Long Logical Sector Size Proposal

To: T13 Technical committee
From: Dan Colegrove
Hitachi Global Storage Technologies
2903 Carmelo Dr.
Henderson, NV 89052
Phone: 702-614-6119
Fax: 702-614-7955
Email: daniel.colegrove@hgst.com
Date: July 15, 2003

Figure ZZ. Long Logical and Long Physical Sector Examples

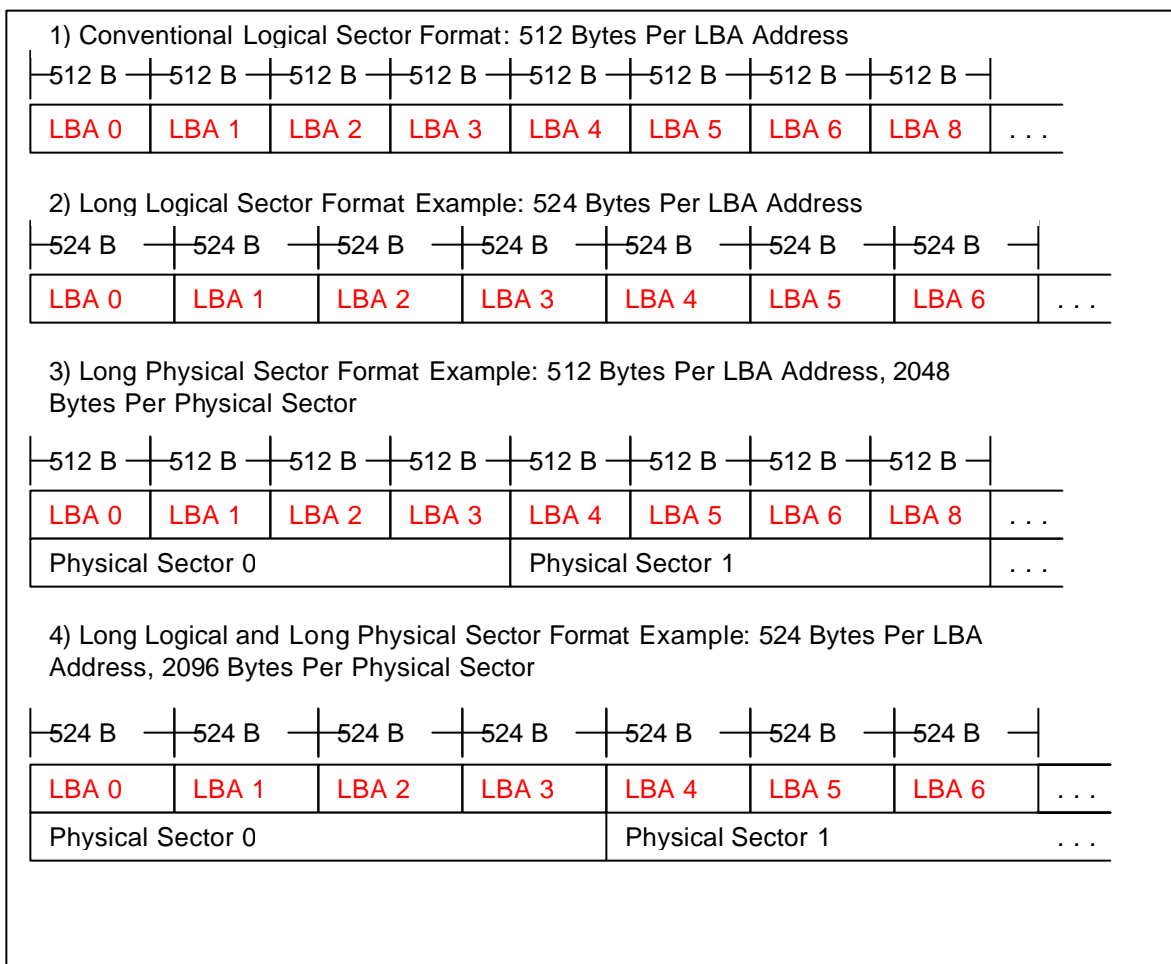
The long physical sector feature set allows a device to be formatted so that there are multiple logical sectors per physical sector on the media. Each physical sector has an ECC field. This allows, for example, a device to have 2048 word physical sectors each containing 8 logical sectors, or one ECC field per 8 256 word logical sectors, see figure ZZ example 3.

Table 1 describes the command behavior of drives that have been manufactured with long logical sectors. Data transfer commands transfer either the long logical sector length or 256 words depending on the command. For example, Read and Write Extended commands transfer data in long logical sectors while Read and Write Log Extended commands transfer 256 words per sector, regardless of the logical sector length. Figure ZZ example 2 shows a diagram of a device formatted with long logical sectors.

The long physical sector feature set and the long logical sector feature set are not exclusive. Figure XX example 4 illustrates a device implementing both the Long Physical Sector and Long Logical Sector feature sets.

Figure C.1 – Unaligned Write Example

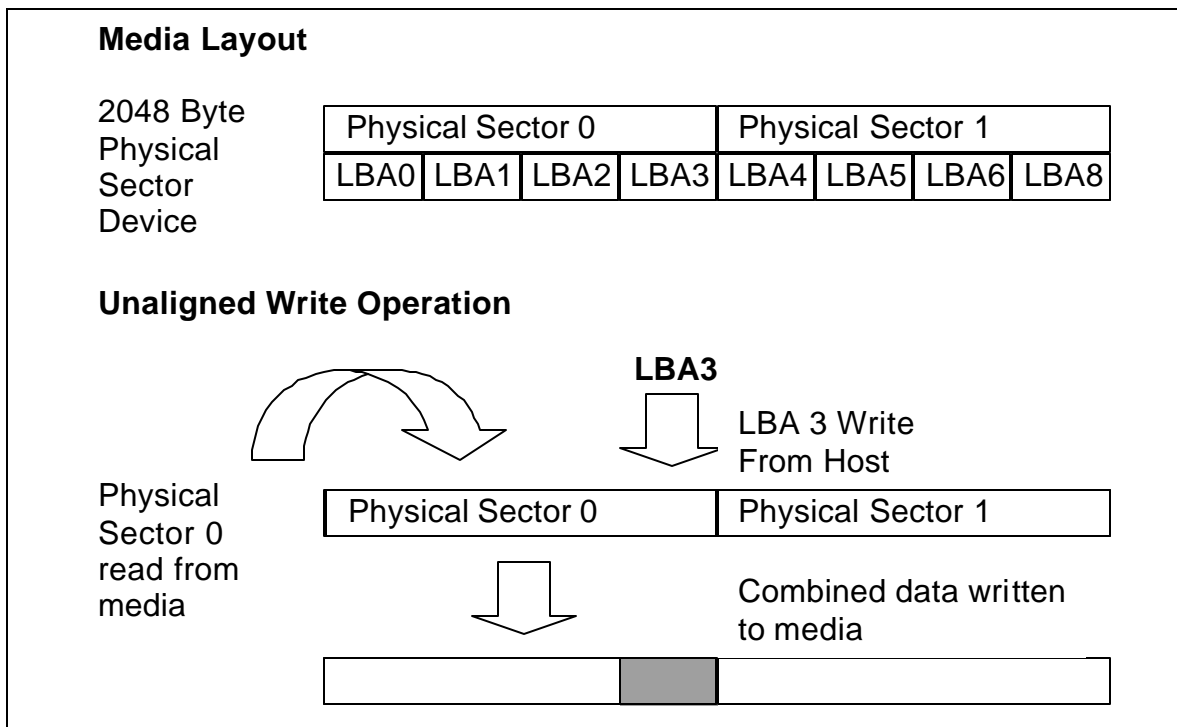
Figure C.1 illustrates an unaligned write on a device with 2048 byte physical sectors. The first four logical sectors, LBA0 – LBA3, reside on physical sector 0. To write only LBA3 the host sends a conventional write command and the data for LBA3. On receipt of the write command the device seeks to the physical sector that contains LBA3, which is physical sector 0. Physical sector 0 is read into the device buffer. Then the new write data for LBA3 is placed in the buffer, overwriting a segment of the buffer. The buffer data is then written to the media, physical sector 0.
